ADDENDUM TO THE CONTRACT DOCUMENTS	Page Number 1	No. of Pages 4
Addendum No. Two (2)	Date Addendum Issued: April 19, 2018	
Issuing Office Department of Natural Resources Support Services Division Procurement Section 550 West 7 th Ave., Suite 1330, Anchorage, Alaska 99501 Phone: 269-8666 Fax: 269-8909	Previous Addenda Issued One	
Project: Battery Creek Fish Passage Battery Creek Road Project No.: ITB 10-001-18	Date and Hour of Quotes Due April 20, 2018 at 2:00 PM. (UNCHANGED)

Bid Documents:

ALUMINUM STRUCTURAL PLATE BOX CULVERT DETAIL 15'-4" x 6'-5"	Drawing Number: BC-A-15.33		Drawn By: "BBK"
	Page Number: 1 OF 1		Date Drawn: 2-11-09
	LANE ENTERPRISES, INC.

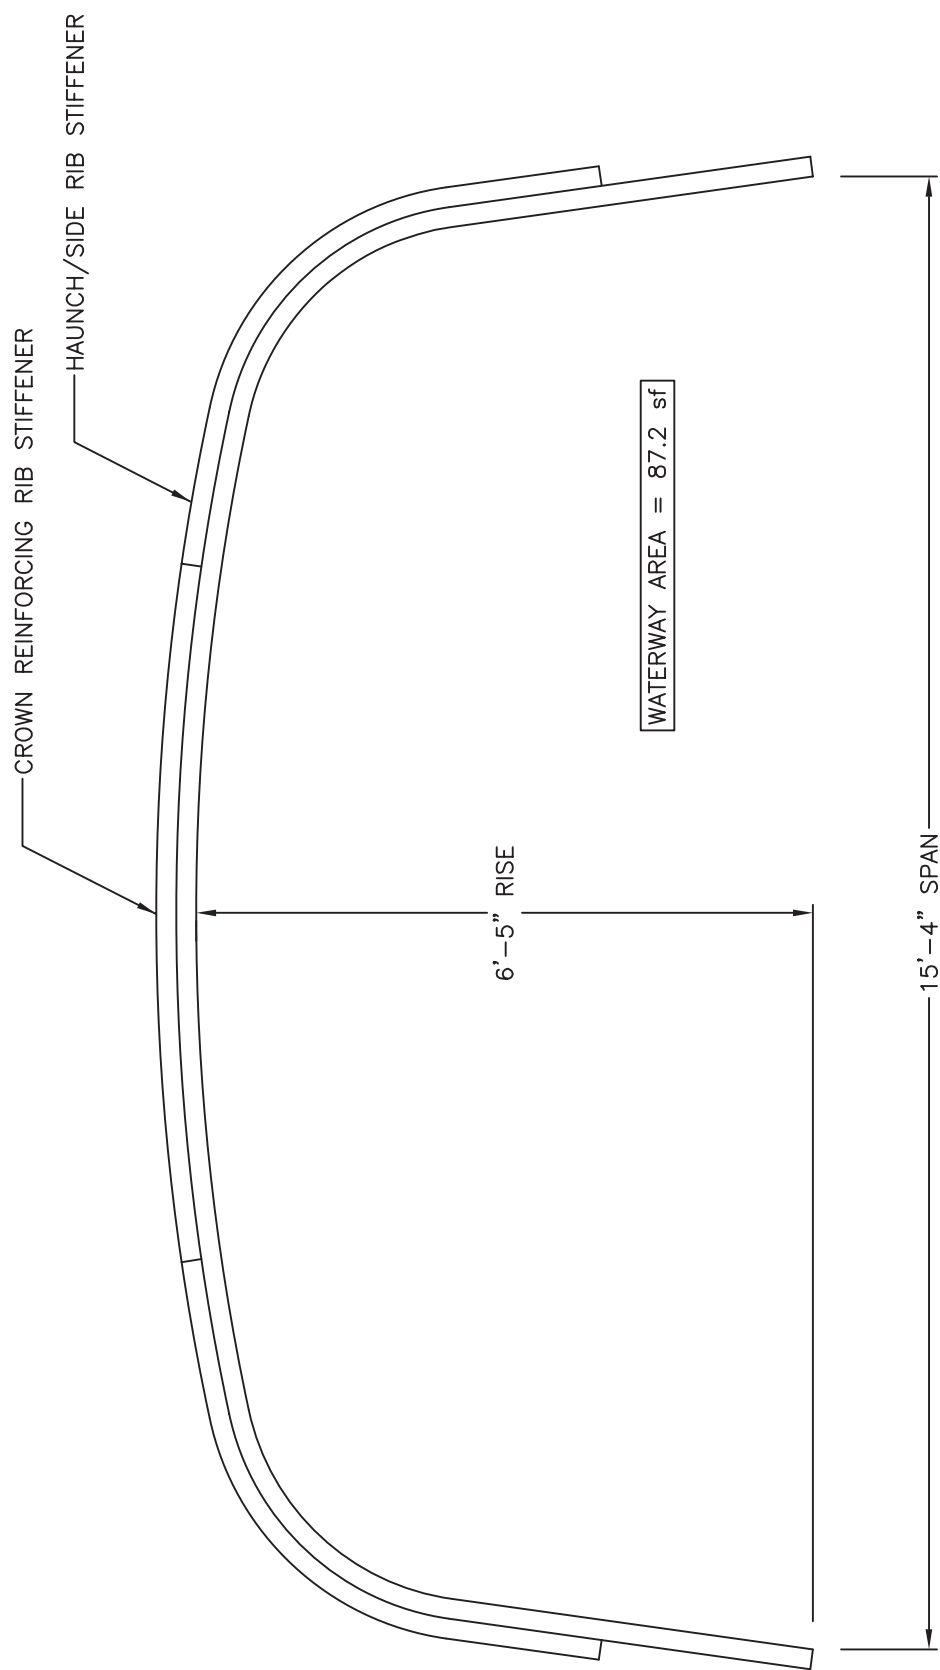
Question 1. There are no details for the box culvert as far as assembly or manufacturer's installation instructions. It appears that transportation to the job site of the culvert is the responsibility of the contractor. Where will the culvert be located when the project begins and what is the shipping configuration (size, weight, palletized/enclosed/loose) of the culvert? Can you provide answers to these questions in an addendum?

The culvert will be staged about ½ mile from the project site, so will need to be transported by the contractor to the project site. Attached are drawings of the culvert. Attached are typical drawings of the culvert and following are links to the detailed installation instructions:

Also, shipping information is: The plate will ship on 2 each 5' X 12' pallets that weigh approximately 4,955 lbs. each.
